SUBJECT: NuScale Power, LLC Response to NRC Request for Additional Information No. 132 (eRAI No. 8971) on the NuScale Design Certification Application

Response to Request for Additional Information

NRC Question No.: 03.08.04-13

Figure 4-1. Single Elements from Pool Wall - Middle (Grid Line C) Exceeding Allowable Concrete Strain in X Direction.

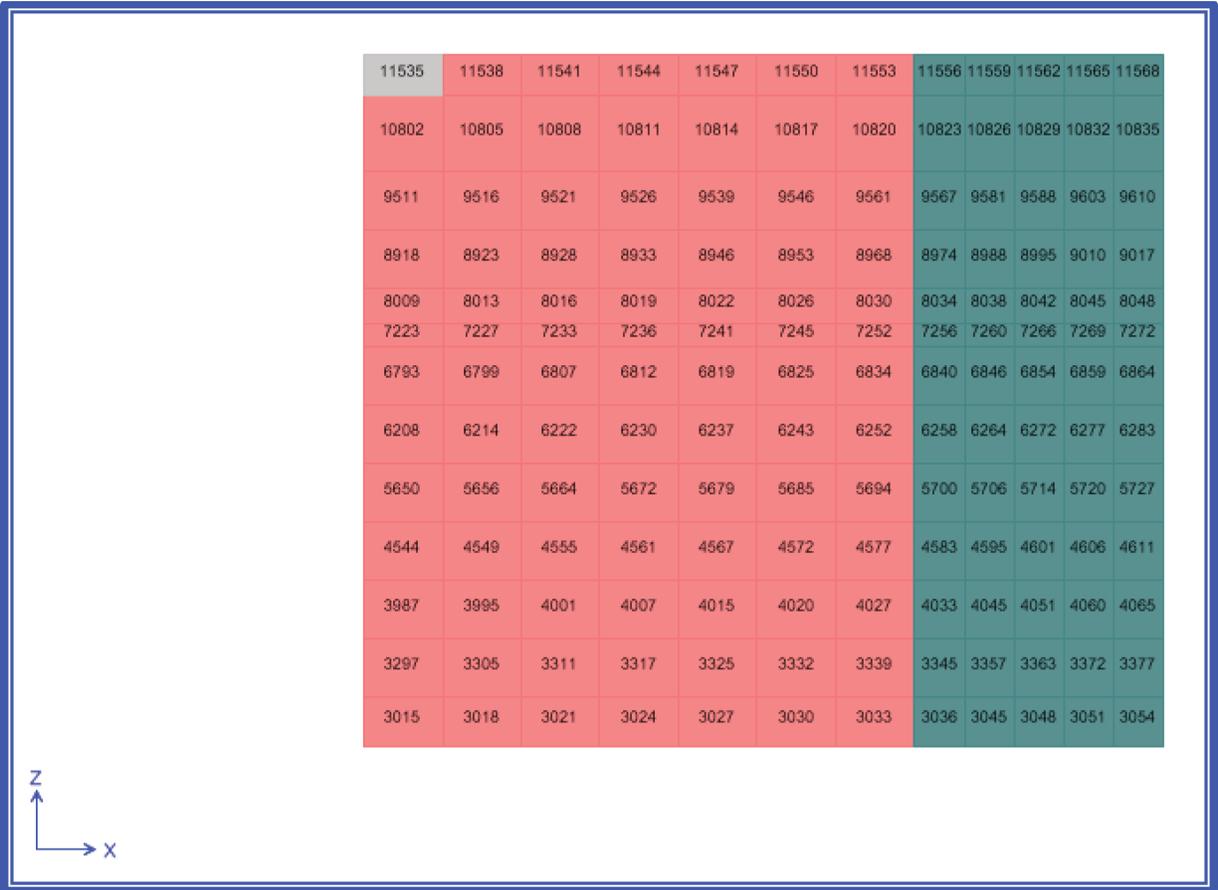
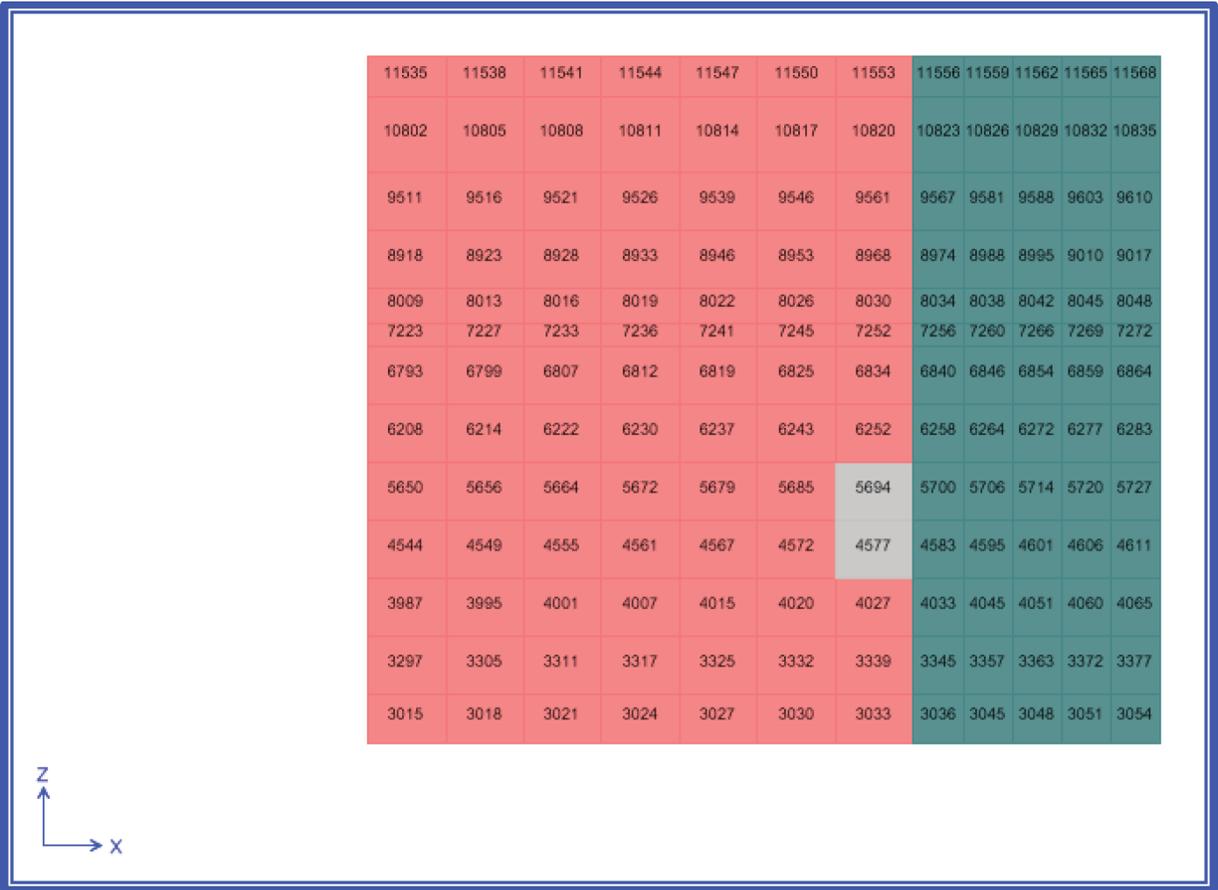
Figure 4-1 and Figure 4-2 present the elements that exceed the allowable strain of $\epsilon_{cu} = 0.003$ for the X and Y direction, respectively.

The maximum concrete strains from SDH for any element of the different walls are extracted. Table 4-1 shows a summary of the strain-based concrete design check for all walls. The total strain in the concrete is less than $\epsilon_{cu} = 0.003$ at all locations except for the middle pool wall at Grid Line C.

Figure 4-3. Single Elements from Outer Wall - North (Grid Line A) with Insufficient Thermal Ta+Pa Strain Capacity for Load Combination 9-9 in Y Direction.

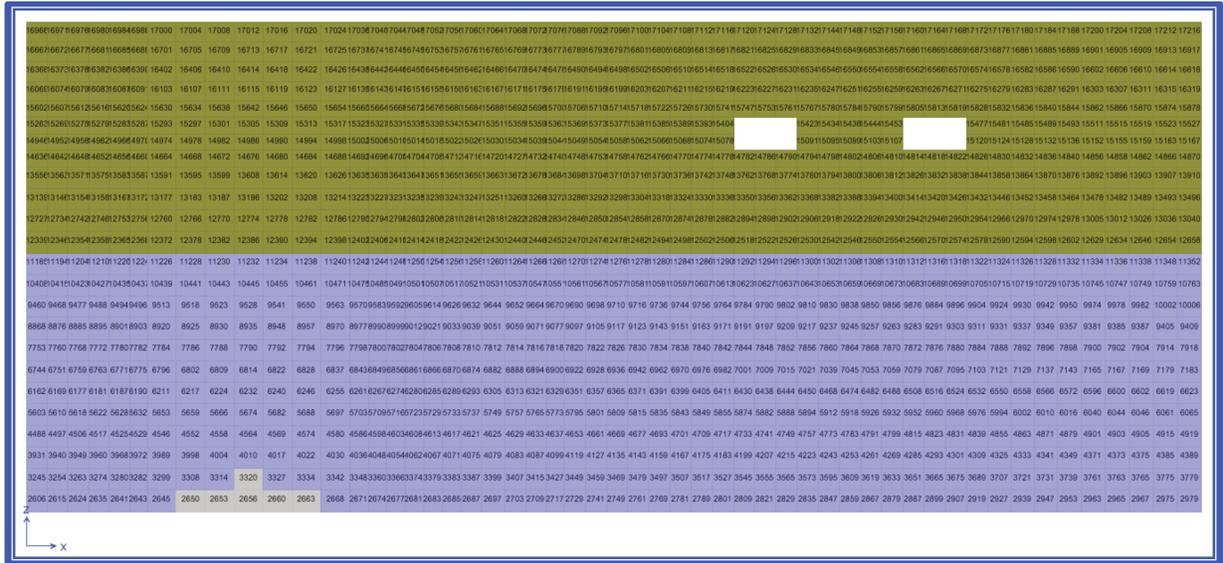
The total strain in Y-direction exceeds $1.2\epsilon_y$ for SDH+ T_a+P_a case for certain elements given in Figure 4-3. After averaging the single elements for load combination 9-9 using a strain contour based on the location, the strain check criteria is satisfied and the wall is considered acceptable.

Figure 4-4. Single Elements from Pool Wall - North (Grid Line B) with Insufficient Thermal T_a+P_a Strain Capacity for Load Combination 9-9 in X Direction.

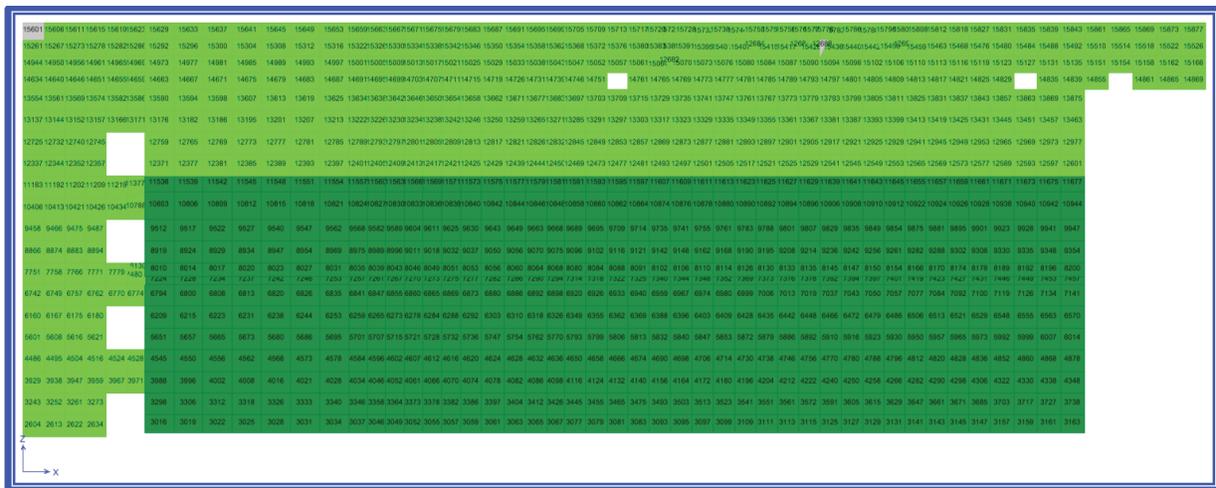
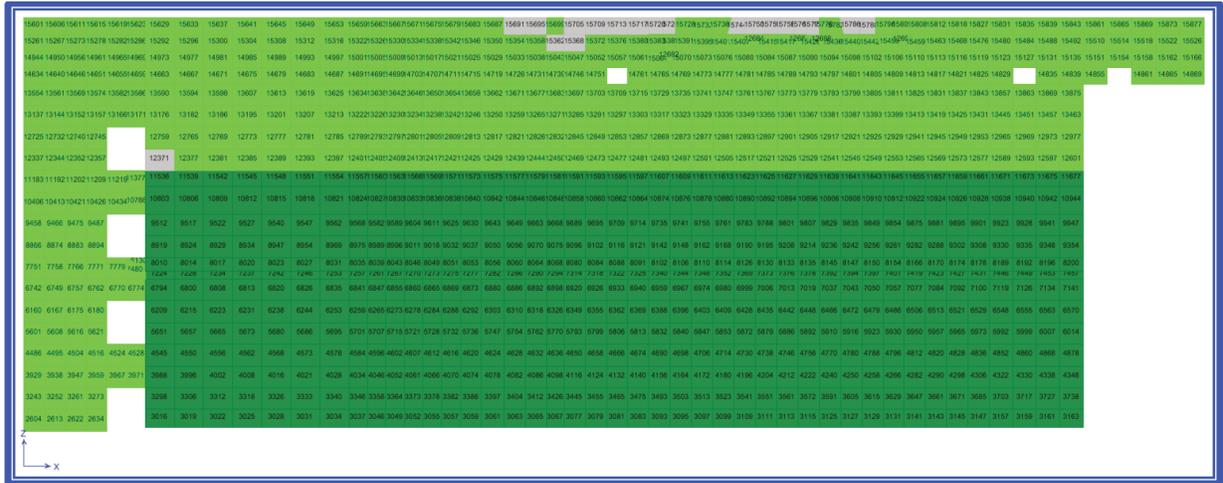
As shown in Table 4-5, the total strain in the steel is less than $1.2\epsilon_y$ (2.483×10^{-3}) at all locations for load combination 9-6. However, there is exceedance for load combination 9-9. For groups of elements where adding the maximum strain from T_a+P_a would make the average fail, a more accurate T_a+P_a strain was obtained based on its location using the strain contour. Please note that the maximum SDH strain and maximum thermal strain do not necessarily occur at the same location, therefore, the maximum combined strain is not the sum of both maximum strains. Since the strain from T_a+P_a is 1.053×10^{-3} , the remaining allowed strain from SDH is 1.430×10^{-3} . The elements that exceed this allowed strain are presented in Figure 4-4 and Figure 4-5 for the X and Y directions, respectively.

Figure 4-6. Single Elements from Pool Wall - East (Grid Line 6) with Insufficient Thermal T0 Strain Capacity for Load Combination 9-6 in X Direction.

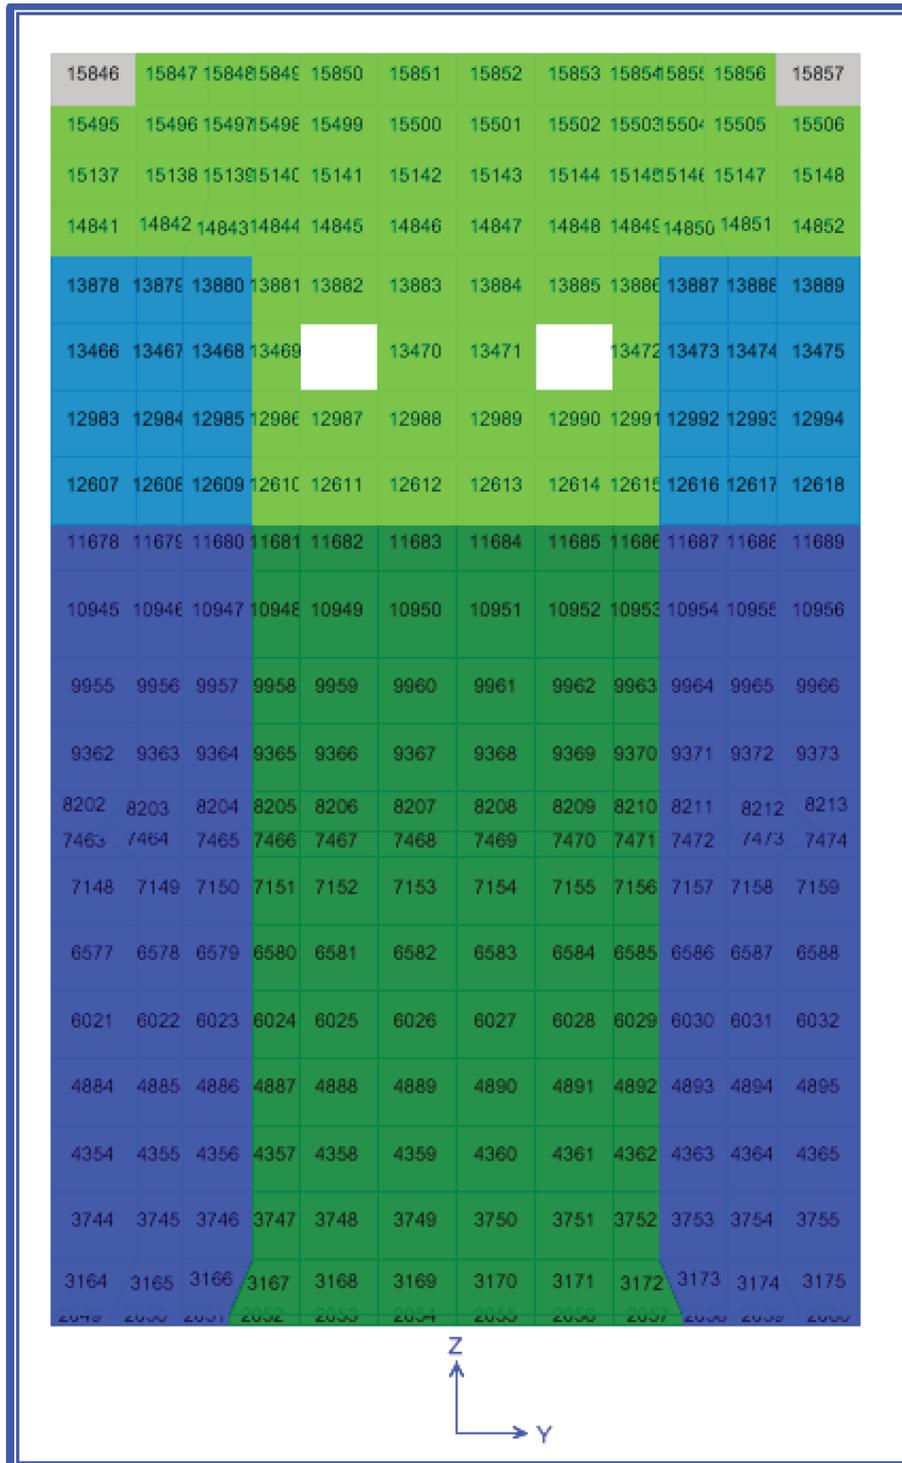
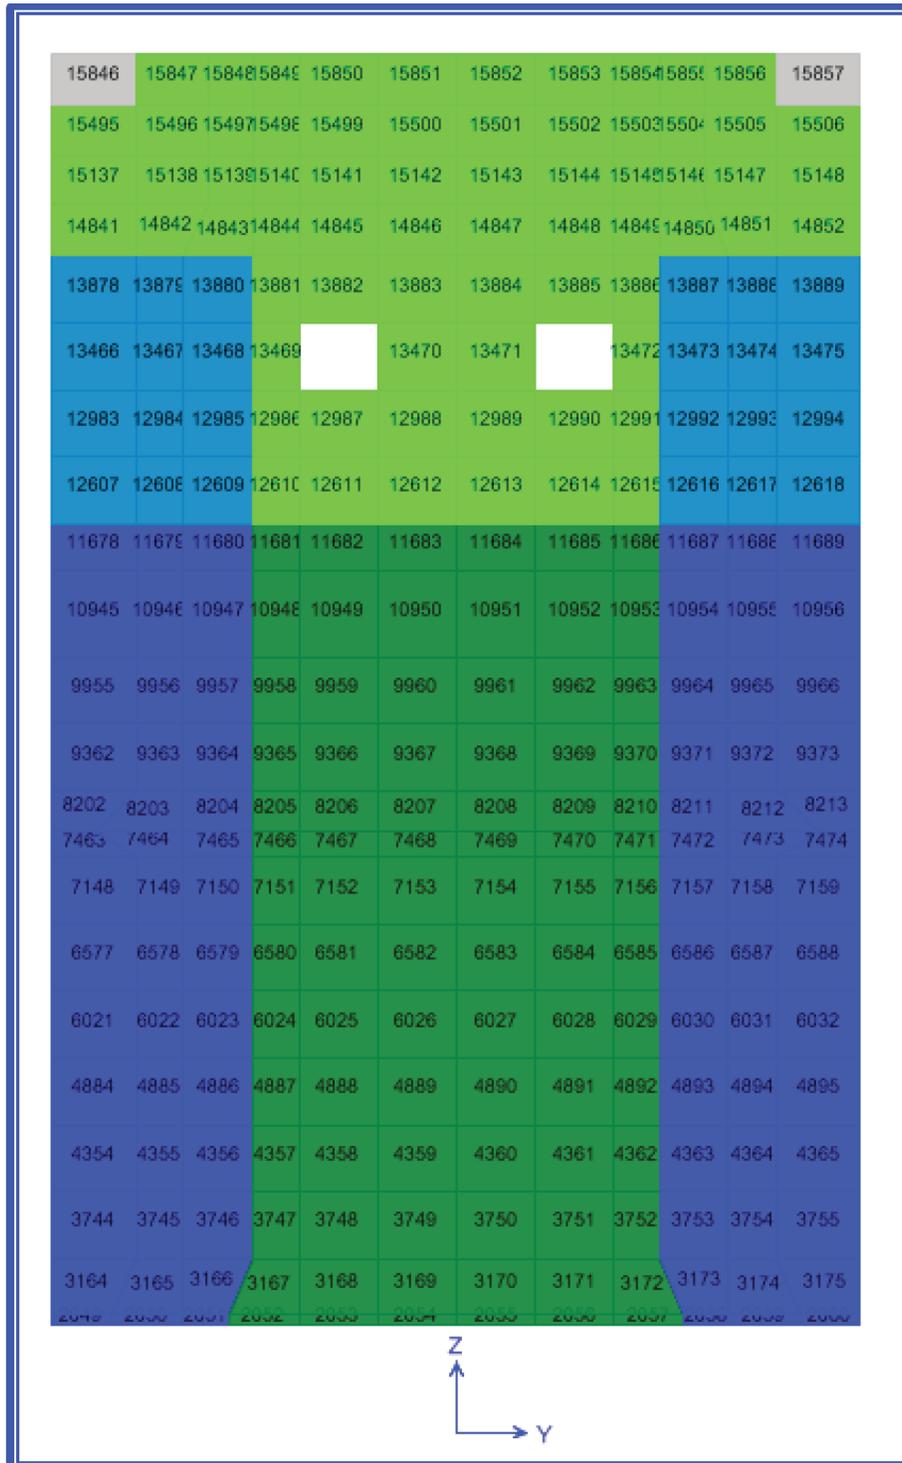
Since the strain from T_0 is 0.317×10^{-3} , the remaining allowed strain from SDH is 2.166×10^{-3} . The elements that exceed this allowed strain are presented in Figure 4-6 and Figure 4-7 for the X direction for load combinations 9-6 and 9-9 respectively. An averaging for these exceeding elements is performed in Table 7-17.

Figure 4-8. Single Elements from Pool Wall - Middle (Grid Line C) with Insufficient Thermal T0 Strain Capacity for Load Combination 9-6 in X Direction.

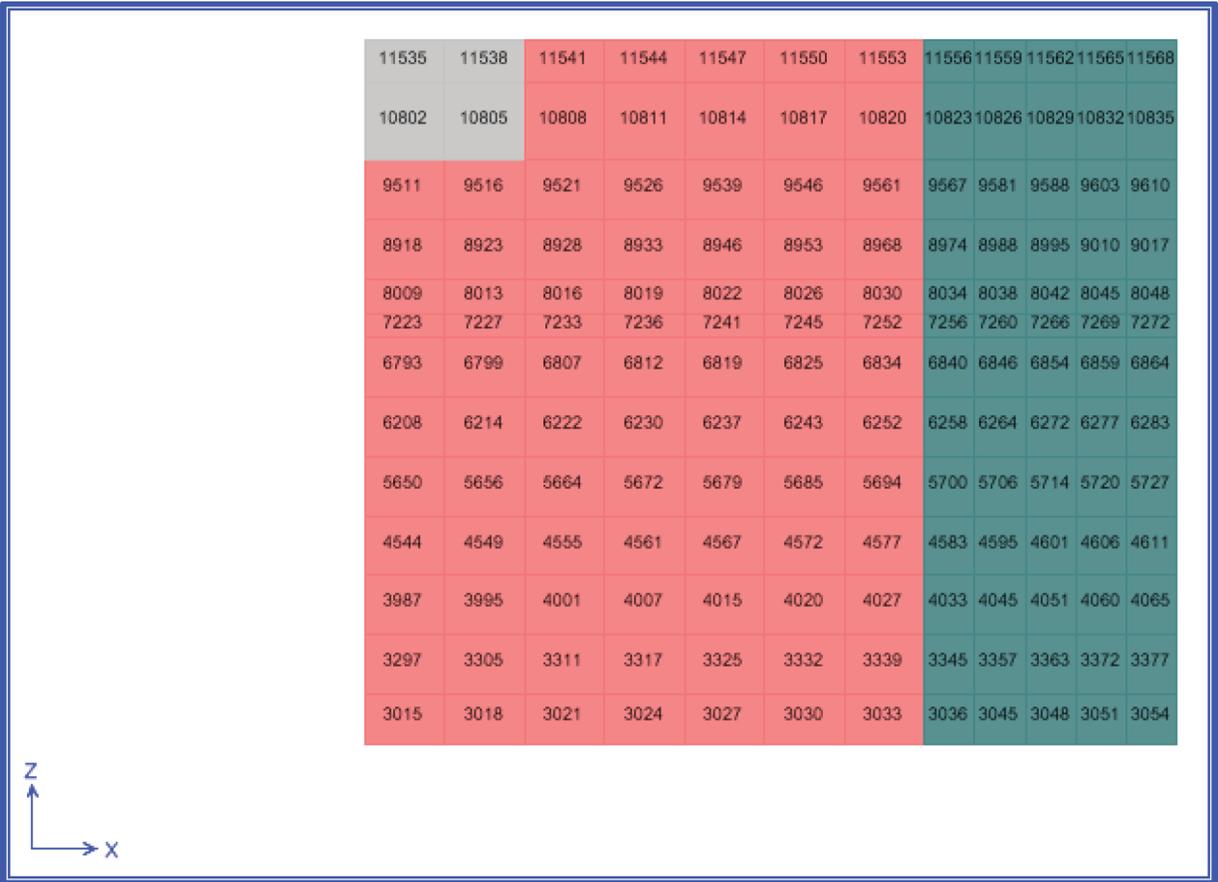
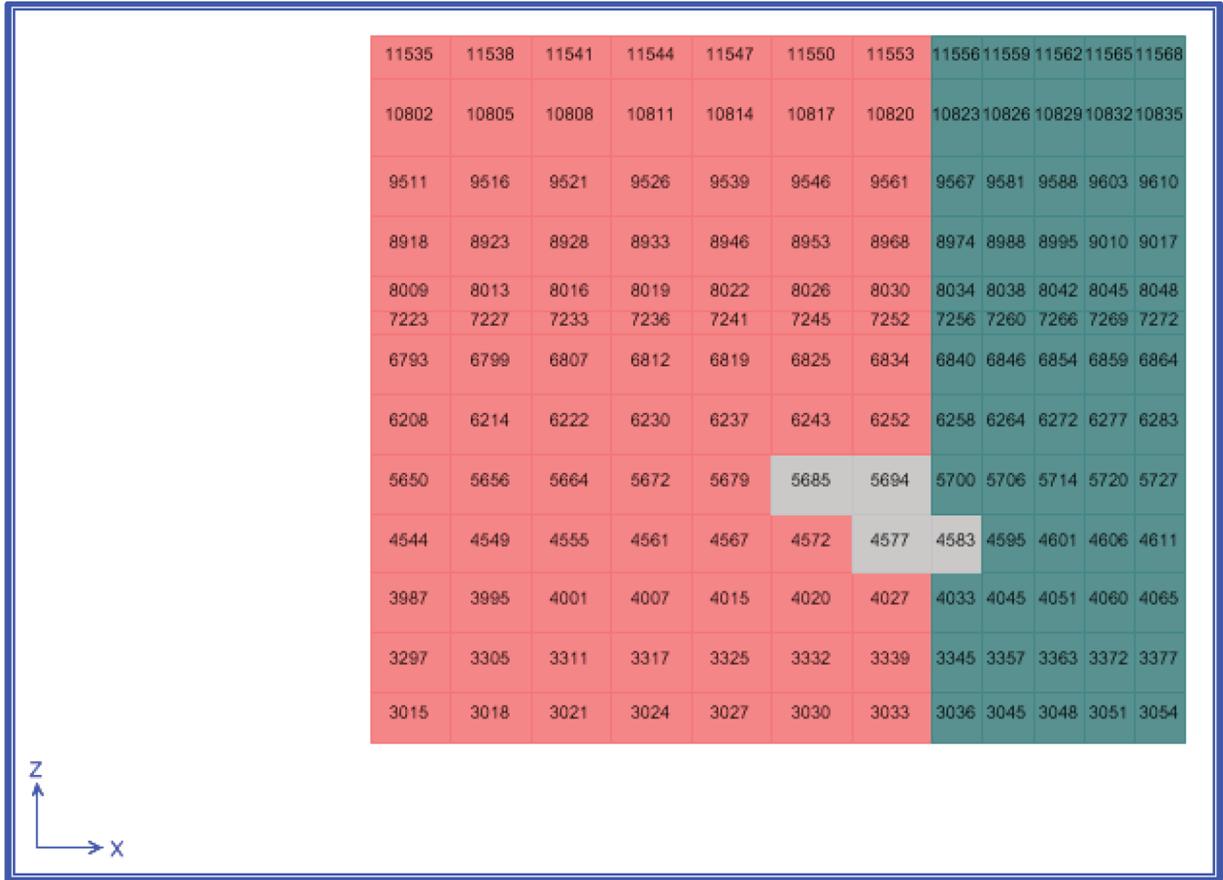
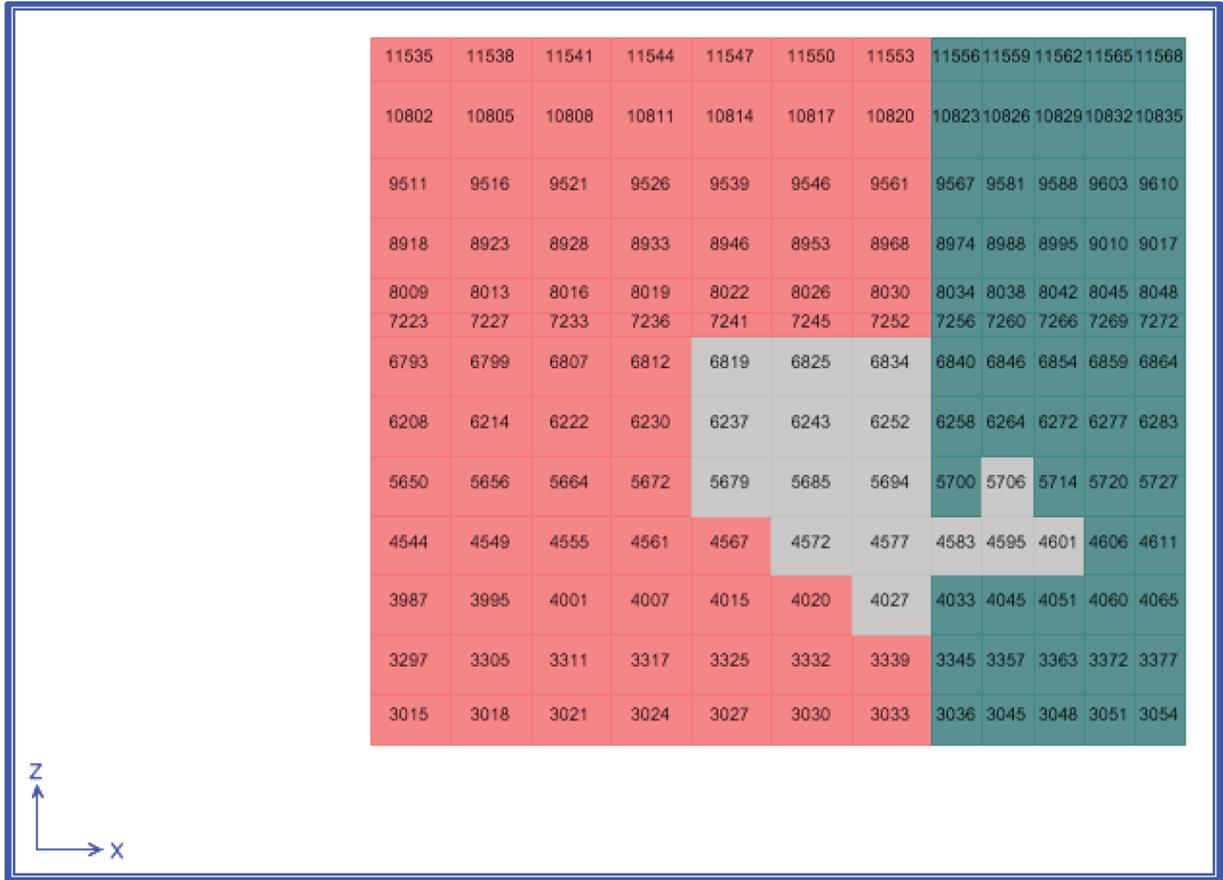
The total strain in the steel exceeds $1.2\epsilon_y$ for both wall thicknesses for both load combination 9-6 and 9-9. Figure 4-8 through Figure 4-11 show the elements that exceed the allowable strain for combinations 9-6 and 9-9 in X and Y directions.

The total strain in the steel is less than $1.2\epsilon_y$ (2.483×10^{-3}) after averaging the single elements without sufficient thermal capacity for load combination 9-6, therefore the condition is satisfied and the wall is considered acceptable. For groups of elements where adding the maximum strain from T_a+P_a would make the average fail, a more accurate T_a+P_a strain was obtained based on its location using the strain contour.
